SUBJECT: COMANCHE PEAK NUCLEAR POWER PLANT, UNITS 3 AND 4
DOCKET NUMBERS 52-034 AND 52-035
RESPONSE TO REQUEST FOR ADDITIONAL INFORMATION NO. 5798
(SECTION 3.7.2)

RAI NO.: 5798 (CP RAI #221)

SRP SECTION: 03.07.02 - Seismic System Analysis

QUESTION NO.: 03.07.02-21

Figure 1. Computed ATF for RB Complex PCCV Structure for All Elevations in NS Direction

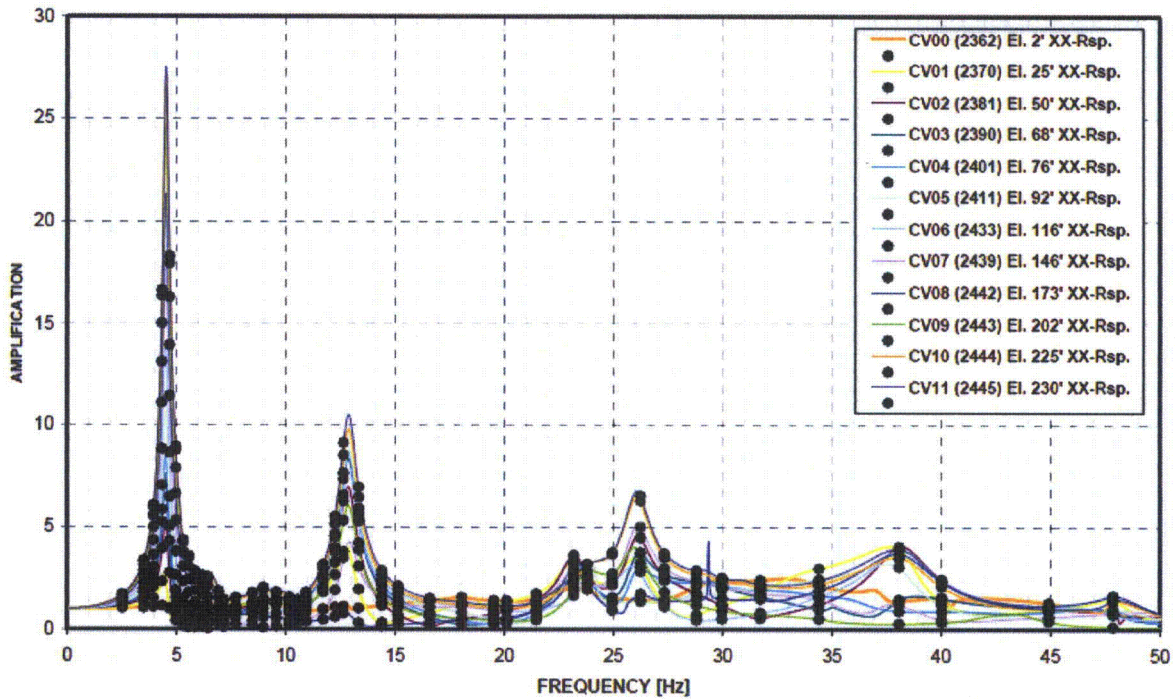
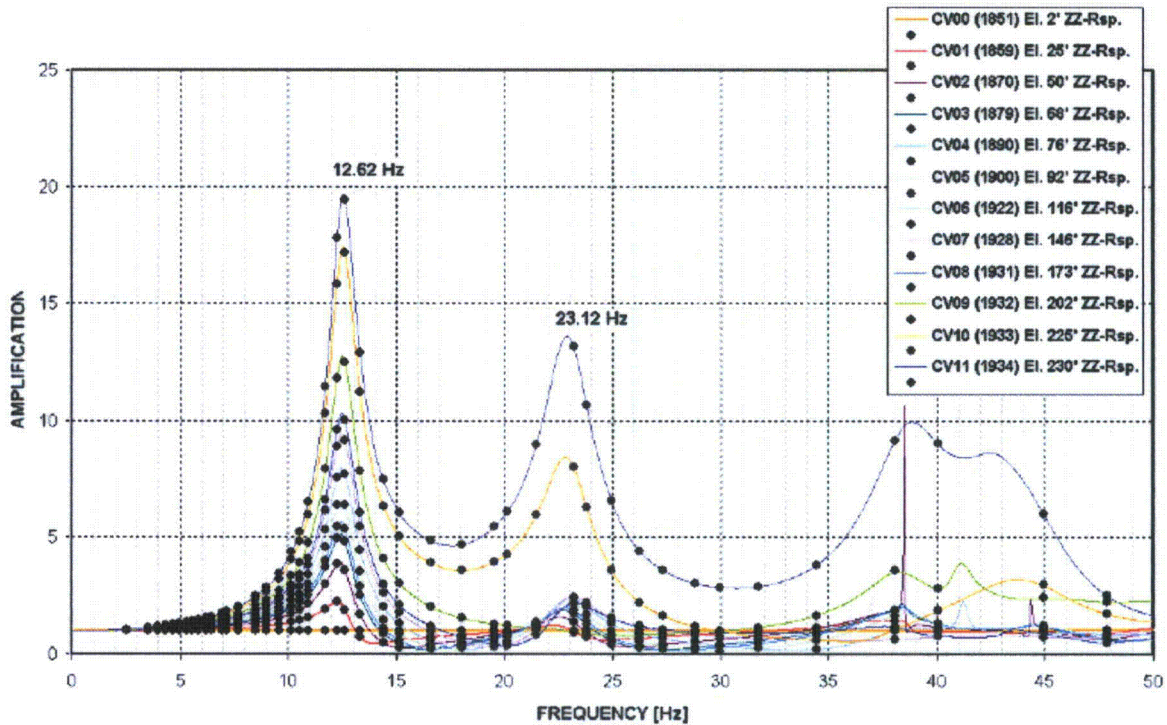
1. Confirm whether the SASSI Subtraction method is used in the analyses of seismic category I standard and site-specific structures.
 2. Provide how Luminant addressed the technical and software quality assurance issues raised by DNFSB letter in the version of SASSI which Luminant uses for analyses of all seismic category I structures part of the Comanche Peak Units 3 and 4.
 3. If the SASSI Subtraction method is used by Luminant, provide an assessment to establish: a) the seismic analyses performed in support of the Comanche Peak RCOL application does not contain any errors or anomalies as identified in DNFSB letter, b) the quality assurance steps taken to ensure that any future seismic analyses in support of the Comanche Peak application will be free from errors or anomalies as identified in DNFSB letter.
-

Review of the computed ATF for the Comanche Peak embedded structure analyses indicated that there are no anomalies associated with the Subtraction method that could significantly affect the computed ISRS or cause unconservative results. Most of the computed ATF functions are smooth over the entire frequency range from 0 to 50 Hz, which was the highest cut-off SSI frequency.

Representative examples are given in Figures 1 through 8 below for the computed ATF for various locations and soil cases for the RB complex, PSFSV, ESWPT and UHSRS. With a few exceptions, all curves are smooth and do not indicate any sharp peaks that could be a Subtraction method numerical instability. For the PSFSV ATF in the Z-direction (Figure 4), a number of sharp peaks, corresponding to data plot points are visible particularly above 40 Hz. Even assuming that these high-frequency peaks are spurious peaks associated with the Subtraction methodology and not associated with interpolation of data, they do not affect the ISRS, which have significant values at much lower frequencies due to the CSDRS-shaped seismic input motion. Another exception occurs for a UHSRS ATF as shown in Figure 8, where a sharp peak occurs at approximately 26 Hz. Due to the narrow bandwidth of the ATF spike and the fact that the ISRS peaks have much larger bandwidth than the ATF peaks, ATF spikes such as the one shown in Figure 8 will have negligible influence on the ISRS, and will result only in increases in ISRS amplitude, which is in the conservative direction.
